# Access Compliance Report

### (Curb Ramps)

Intersection ID: 7635	Main Street: PHEASANT_GLEN_RD	Cross Street: QUAIL_ST	Location: SE
ADA ID: 87E49B950D1D	Ramp Type: PerpDiag	Initial Pass/Fail: Fail	Overall Compliance: No
Codes/Mitigation Info/Possible Solution		Field Measurements/Component Compliance

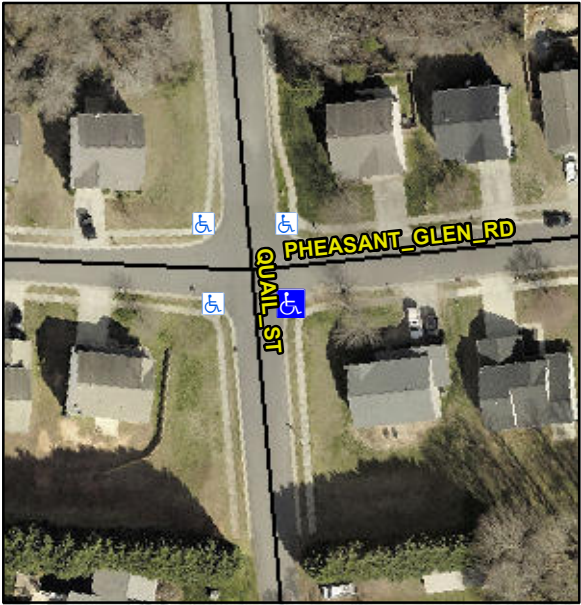
Possible Solutions:	Compliance	Description	Data	Compliance	Description	Data
	Remove & Replace Curb Ramp With Two New Directional Ramps or Equivalent.	N/A	Ramp Length (in)	47.5	No	Ramp Slope (%)	11.0
<p>Surveyor Notes:</p> <p>N/A</p> <p>PROW/ADA:</p> <p>Not Found, R304.5.1, R304.2.2, R304.5.3</p>		No	Ramp Width (in)	43.5	No	Ramp XSlope (%)	12.5
		N/A	Flare Type LT	N/A	N/A	Flare Type RT	N/A
		N/A	Flare Slope LT (%)	N/A	N/A	Flare Slope RT (%)	N/A
		N/A	Flare Traversable LT?	N/A	N/A	Flare Traversable RT?	N/A
		N/A	Landing Length (in)	N/A	N/A	DWS Provided?	N/A
		N/A	Landing Width (in)	N/A	N/A	DWS Contrast?	N/A
		N/A	Landing Slope (%)	N/A	N/A	DWS Length (in)	N/A
		N/A	Landing X Slope (%)	N/A	N/A	DWS Full Width?	N/A
		N/A	Landing Curb? (Y/N)	N/A	N/A	DWS Offset (in)	N/A
		N/A	Shared Landing?	N/A			
		N/A	Gutter Ponding?	N/A	N/A	Gutter Slope (%)	N/A
		N/A	Gutter Lip Ht (in)	N/A	N/A	Gutter X Slope (%)	N/A
		N/A	Painted X Walk1?	No	N/A	Painted X Walk2?	No

X Walk 1 Direction	To N		X Walk 2 Direction	To W
		N/A	X Walk 1 Width (in)	N/A	N/A	X Walk 2 Width (in)	N/A
			X Walk 1 Slope (%)	5.7		X Walk 2 Slope (%)	3.4
			X Walk 1 X Slope (%)	4.0		X Walk 2 X Slope (%)	10.7
		N/A	Ramp inside XWalk1?	N/A	N/A	Ramp inside XWalk2?	N/A
			Road Slope (%)	9.6	N/A	Clear Space?	N/A
			Road X Slope (%)	3.0	N/A	Clear Space to XWalk (in)	N/A
		N/A	Any Obstructions?	N/A	N/A	Storm Grate/Utility Hazard?	N/A
			Obstruction Type			Storm Grate/Utility Type	
				N/A			N/A
					Yes	Surface Condition? (G/P)	Good
